Service Bulletin

SEB95-3

FLAP SUPPORT INSPECTION AND ROLLER WASHER INSTALLATION

TITLE FLAP SUPPORT AND ROLLER BEARING INSPECTION/FLAP ROLLER WASHER
INSTALLATION

Figure 1. Flap Support Rib Assembly and Roller Bearing Inspection (Sheet 3)

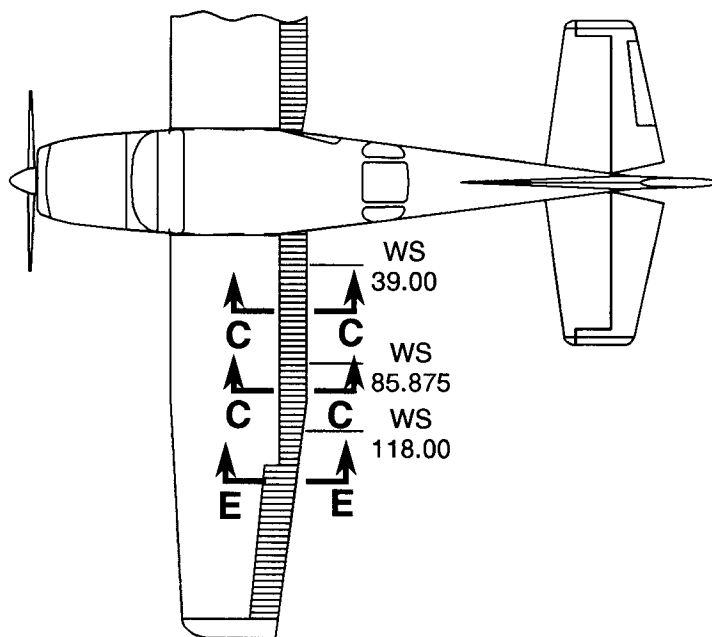
NOTE: Maximum wear and clean-up shall not exceed 0.020 inch material loss. If cracks are present or grooves exceeds a 0.020 inch depth, replace the flap support arms by installing one SK180-44-1 per affected flap station. For airplanes equipped with extended length flaps (refer to Figure 1, Sheet 3) at the outboard flap attach station, install SK180-44-2 or SK180-44-3 as required.

Figure 1. Flap Support Rib Assembly and Roller Bearing Inspection (Sheet 4)

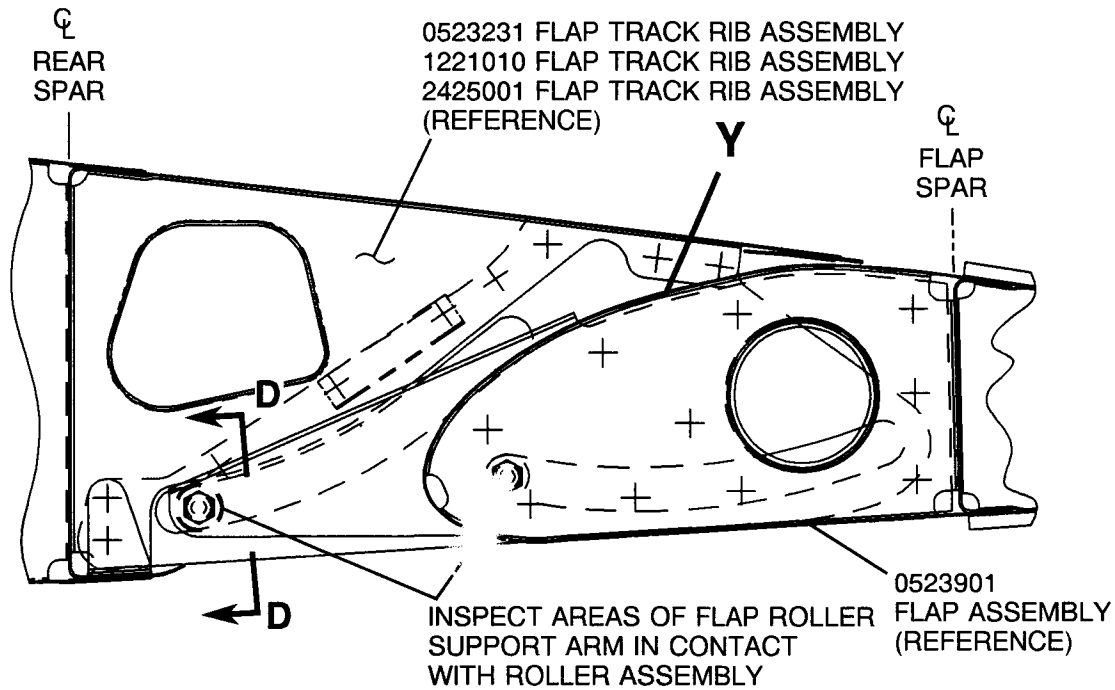
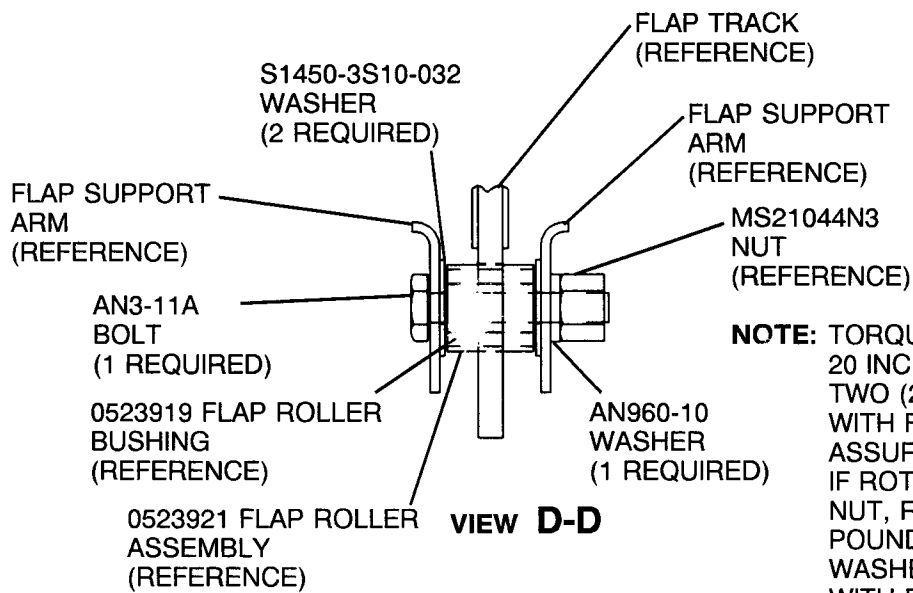
4. (Refer to Figure 1, Sheet 4 View A-A, View B-B, and View C-C and Sheet 5 View E-E.) Use a rag damp with Stoddard solvent (or equivalent) and a nonmetallic abrasive pad such as Scotch Brite, clean the flap support arms.

6. (Refer to Figure 1, Sheet 4, View D-D and Sheet 5, View F-F.) Reassemble and install the roller and roller bushing, at both the forward and aft locations, on the flap tracks.

- A. Install the two (2) new S1450-3S10-032 washers on the forward roller assembly only, one on each side of the roller bushings, with the square-edge side facing the flap roller assembly, (1) AN3-11A bolt and (1) MS21044N3 nut. Install retained hardware in the aft location using the existing bearing retained in step 3.

- B. Torque the MS21044N3 nut to 20 inch-pounds. Check the two (2) S1450-3S10-032 washers with finger pressure to assure they will NOT rotate. If rotation is felt, loosen the nut, retorque to 25 inch-pounds and verify the washer cannot be turned with finger pressure.

NOTE: DO NOT INSTALL S1450-3S10-032 WASHERS ON THE AFT ROLLER ASSEMBLY

NOTE: TORQUE THE MS21044N3 NUT TO 20 INCH-POUNDS. CHECK THE TWO (2) S1450-3S10-032 WASHERS WITH FINGER PRESSURE TO ASSURE THEY WILL NOT ROTATE. IF ROTATION IS FELT, LOOSEN THE NUT, RETORQUE TO 25 INCH-POUNDS, AND VERIFY THE WASHER CANNOT BE TURNED WITH FINGER PRESSURE

Figure 1. Flap Support Rib Assembly and Roller Bearing Inspection (Sheet 6)

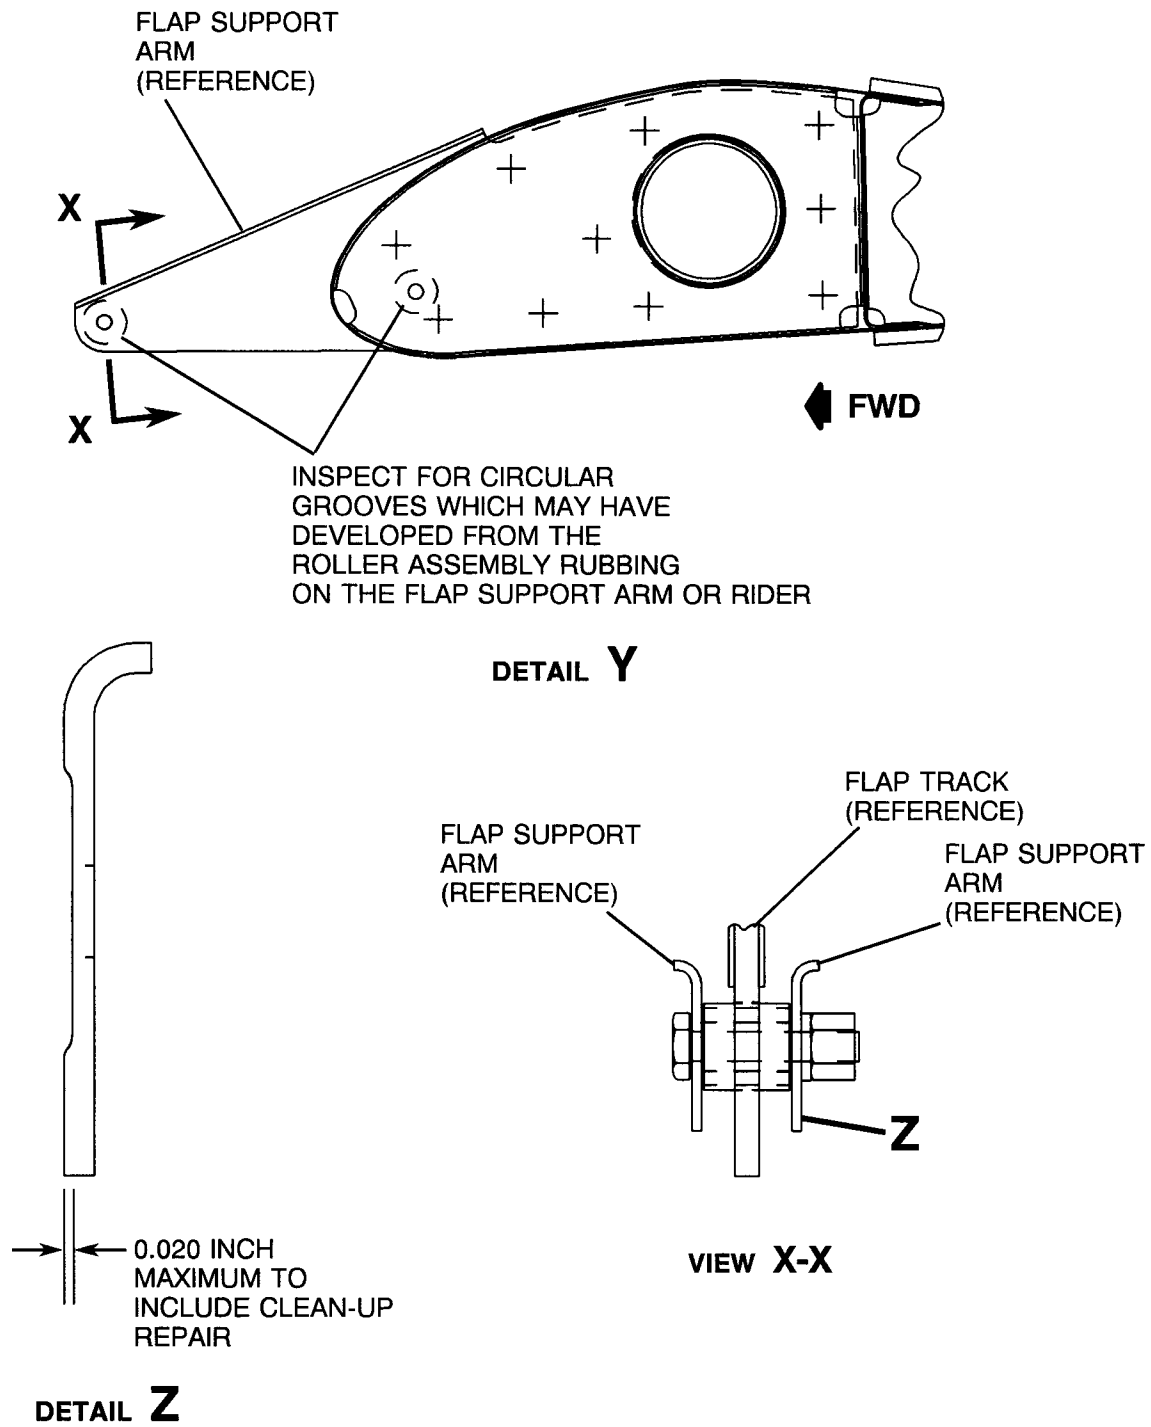
5. (Refer to Figure 1, Sheet 6, Detail Y.) Using a dye penetrant, inspect each flap support arm or rider at the forward and aft roller assembly mounting points for grooves and/or cracks.

NOTE: Circular grooves may have developed from the roller assembly rubbing on the flap support arm or rider. If this condition is present, use an optical or mechanical depth micrometer and measure the depth of the grooves.

CAUTION: DO NOT USE POWERED GRINDING DISC OR HAND FILE FOR BLENDING GROOVES. USE CARE WHEN BLENDING GROOVES NOT TO EXCEED 0.020 INCH TOTAL MATERIAL REMOVED.

- A. If no cracks are present and if any grooves are present, use 400 grit Emory cloth and blend out the grooves using care not to remove excessive material; blending to remove grooves shall not exceed the maximum depth of 0.020 inch.

Figure 1. Flap Support Rib Assembly and Roller Bearing Replacement (Sheet 1 of 9)

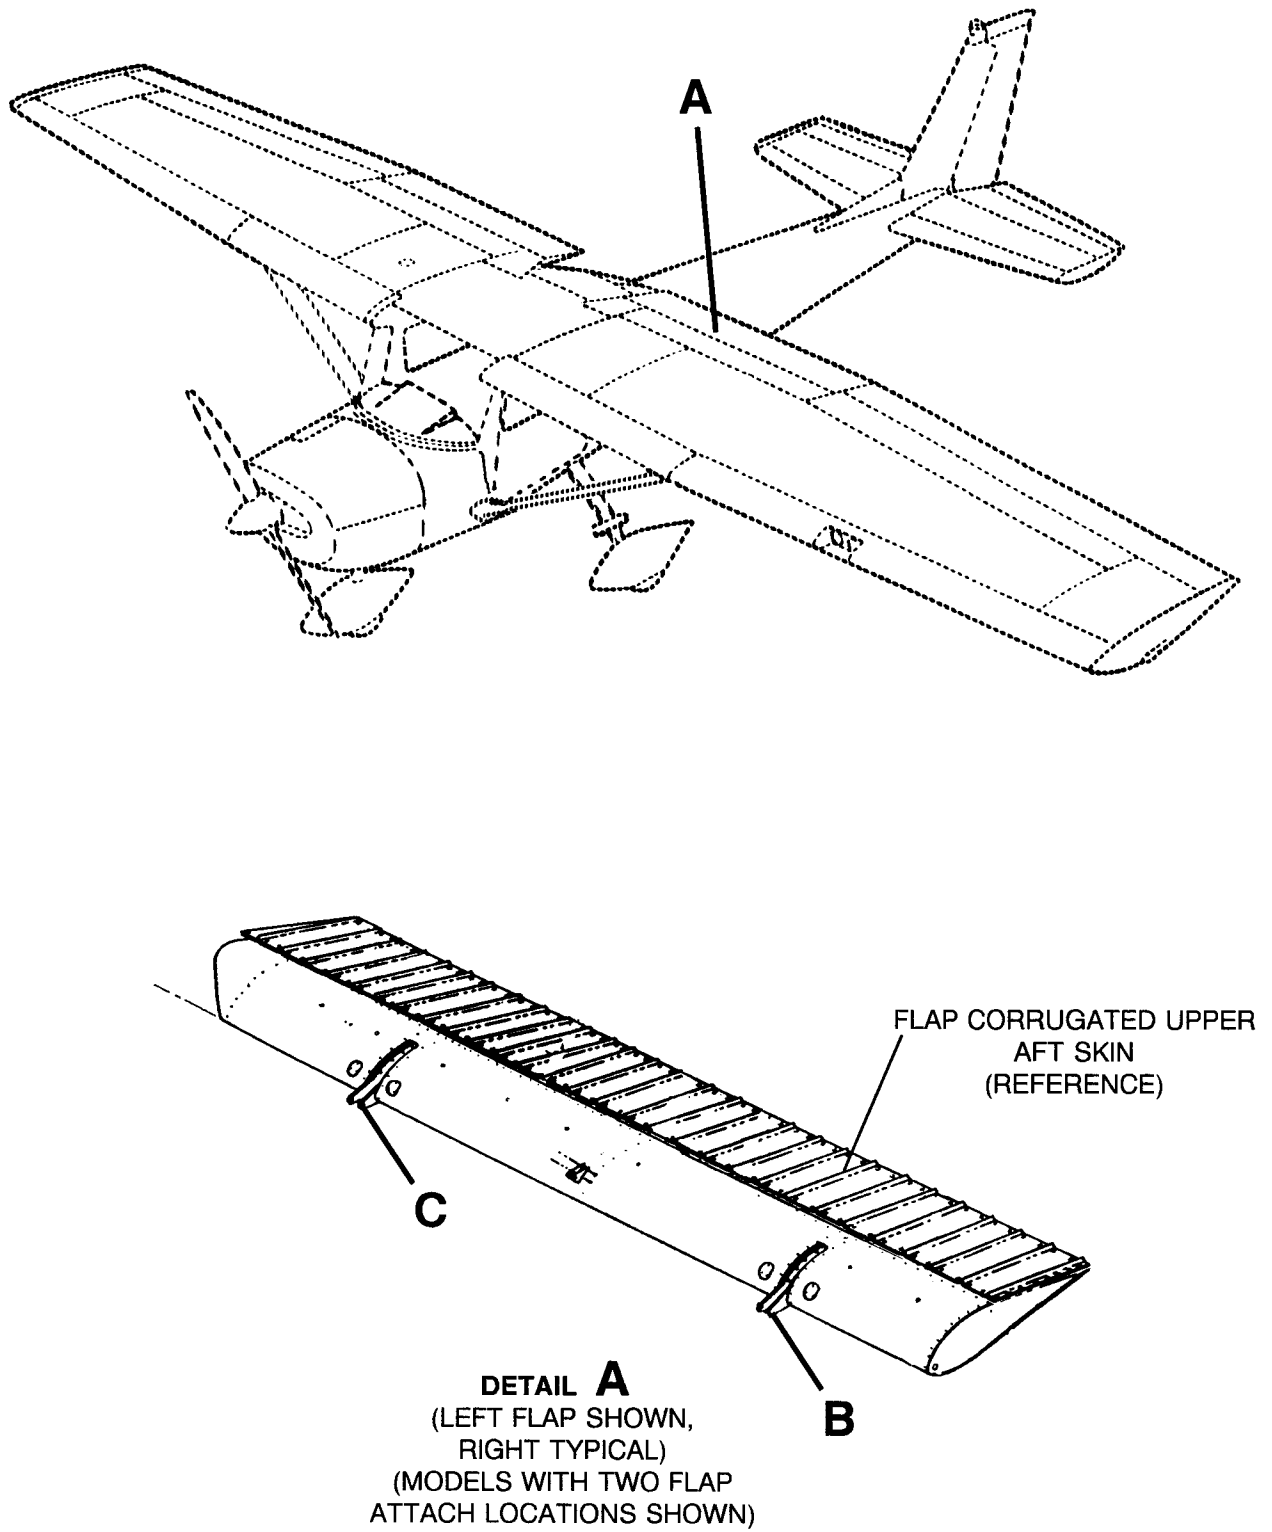
3. Drill out rivets securing the upper corrugated flap skin forward edge across the flap spar edge 4 or 5 rivets past the affected flap support station. (Refer to Figure 1, Sheet 1, Detail A.)

Figure 1. Flap Support Rib Assembly and Roller Bearing Replacement (Sheet 3)

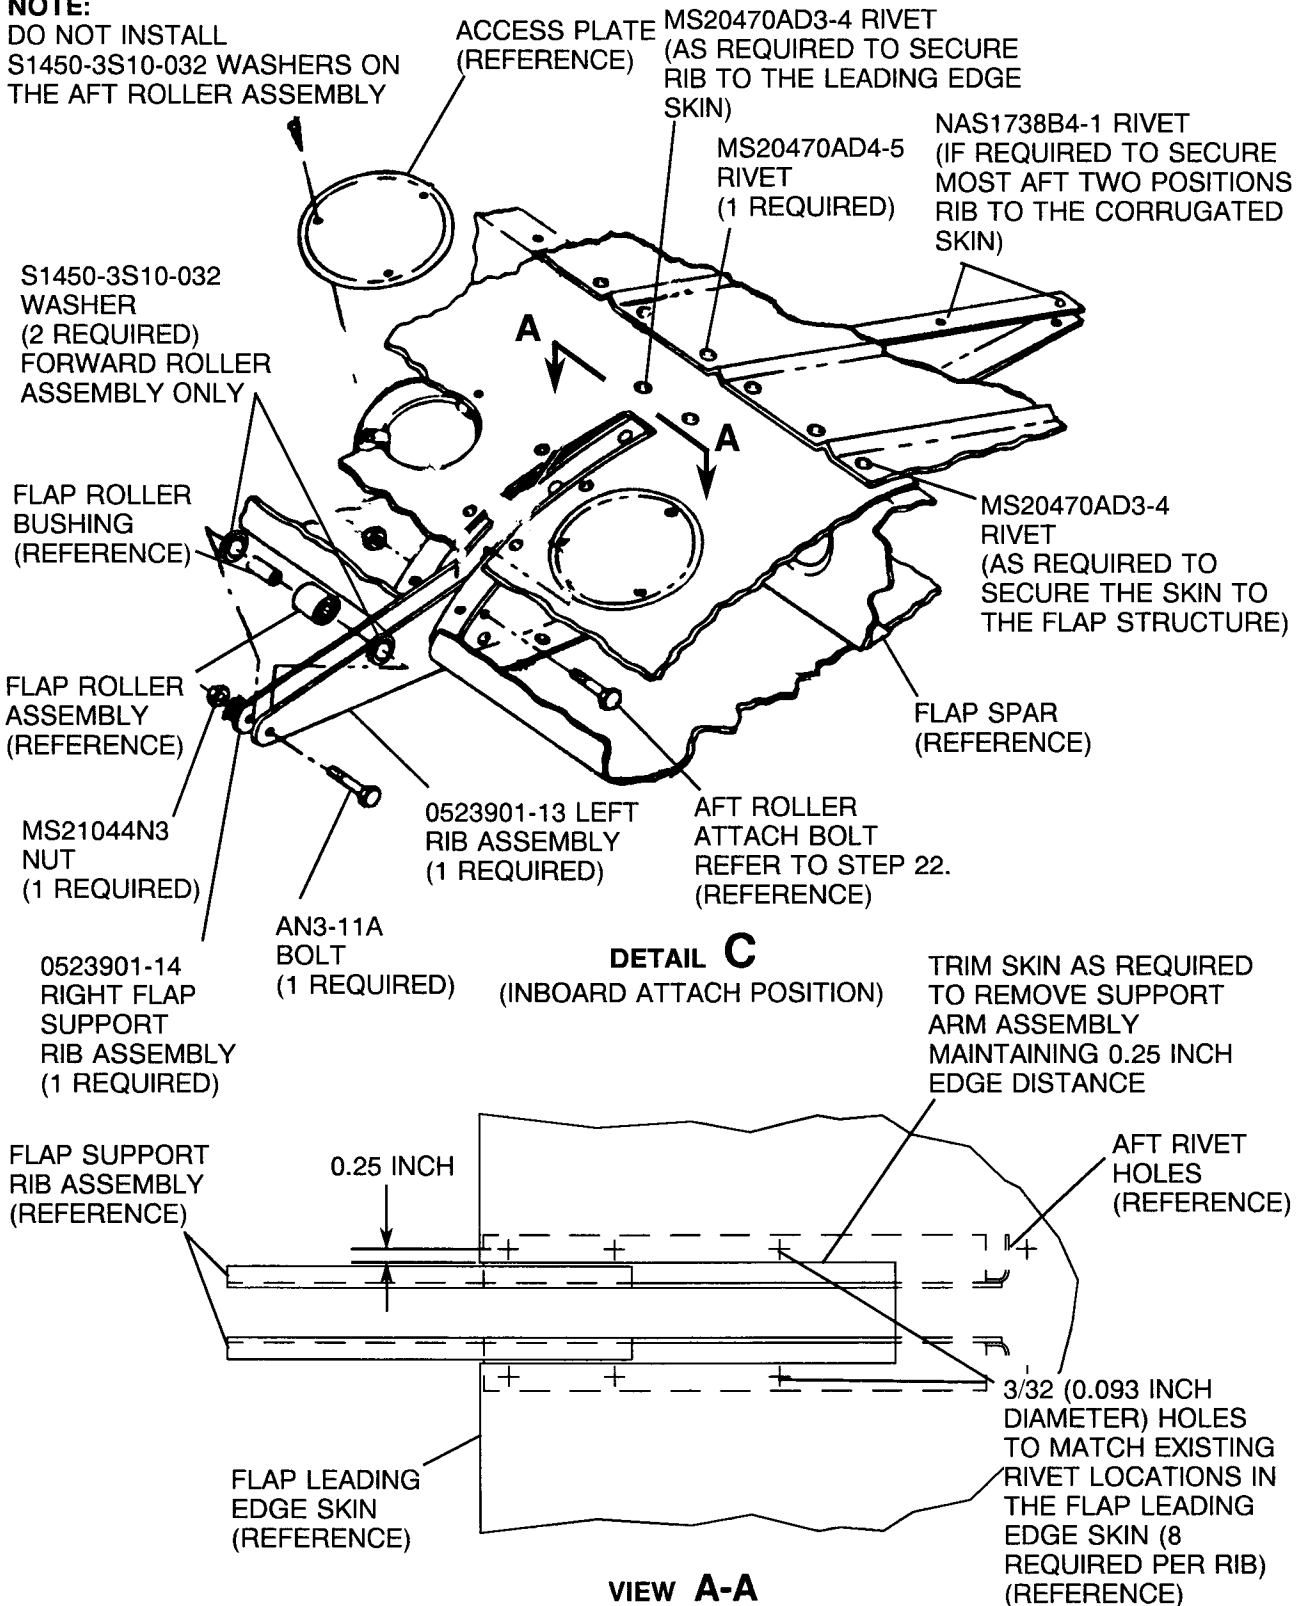
6. Drill out the rivets securing the existing left flap support arm to the leading edge skin and the flap spar. Pull the flap support arm through the hole in the leading edge skin and discard the existing flap support arm. (Refer to Figure 1, Sheet 2, Detail B and Sheet 3, Detail C.)

12. Using a 3/32 (0.093 inch diameter) drill, drill eight holes in the rib flange of the flap support rib to the existing rivet locations in the leading edge skin. Use the line made in step 7 to assure alignment. (Refer to Figure 1, Sheet 3, View A-A.)

16. Using a 3/32 (0.093 inch diameter) drill, drill eight holes into the 0523901-14 rib flange of the flap support rib to the existing rivet locations in the leading edge skin. (Refer to Figure 1, Sheet 3, View A-A.)

18. Secure the new 0523901-13 flap support arm to the leading edge of the flap using MS20470AD3-3 rivets, removing the temporary metal fasteners as required. (Refer to Figure 1, Sheet 2, Detail B, and Sheet 3, Detail C.)

DO NOT INSTALL
S1450-3S10-032 WASHERS ON
THE AFT ROLLER ASSEMBLY

Figure 1. Flap Support Rib Assembly and Roller Bearing Replacement (Sheet 7)

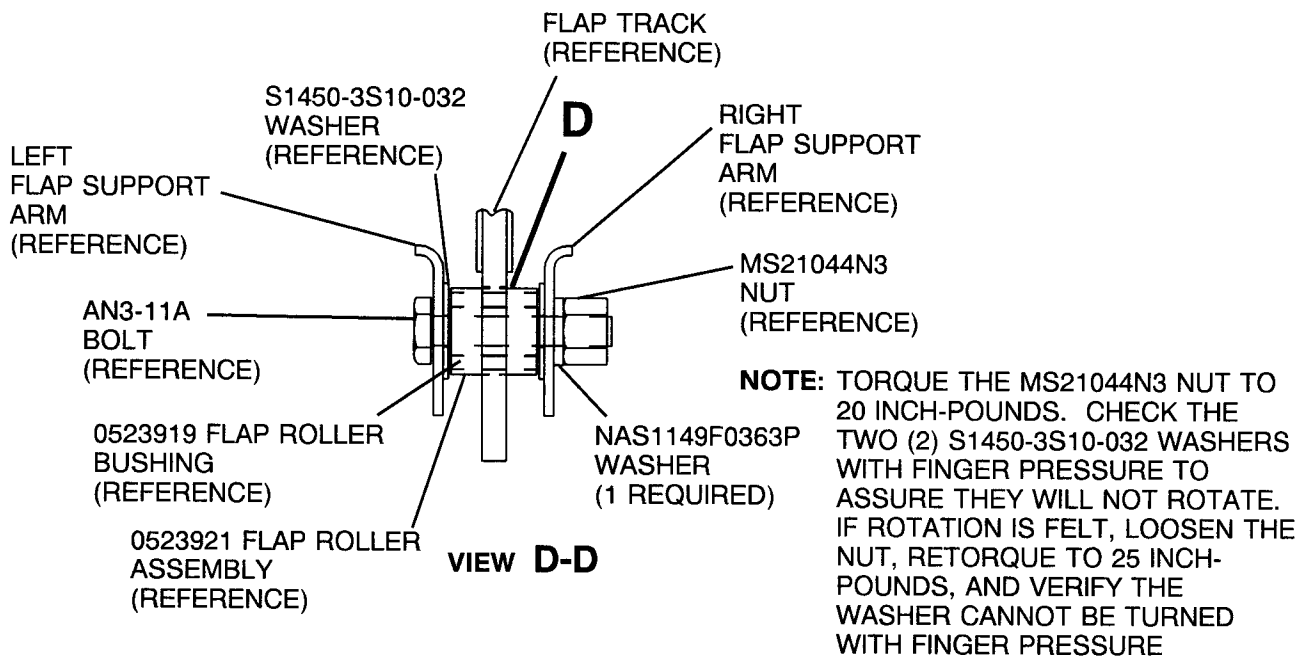
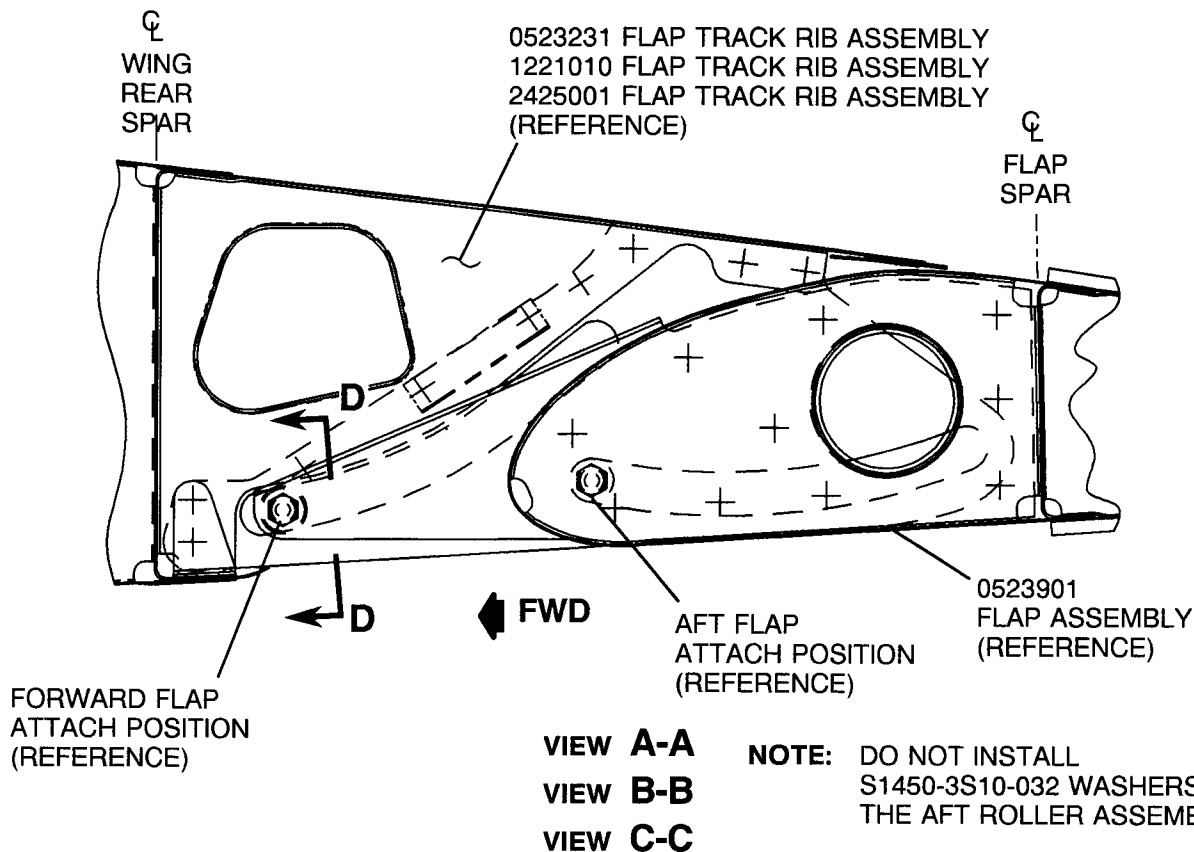
8. Insert the new 0523901-13 left flap support arm in the existing flap support location. Align the aft rivet holes in the flap support arm to the corresponding holes in the flap spar. Secure in position using two temporary metal fasteners. (Refer to Figure 1, Sheet 7, Views A-A, B-B, C-C and Sheet 8, E-E.)
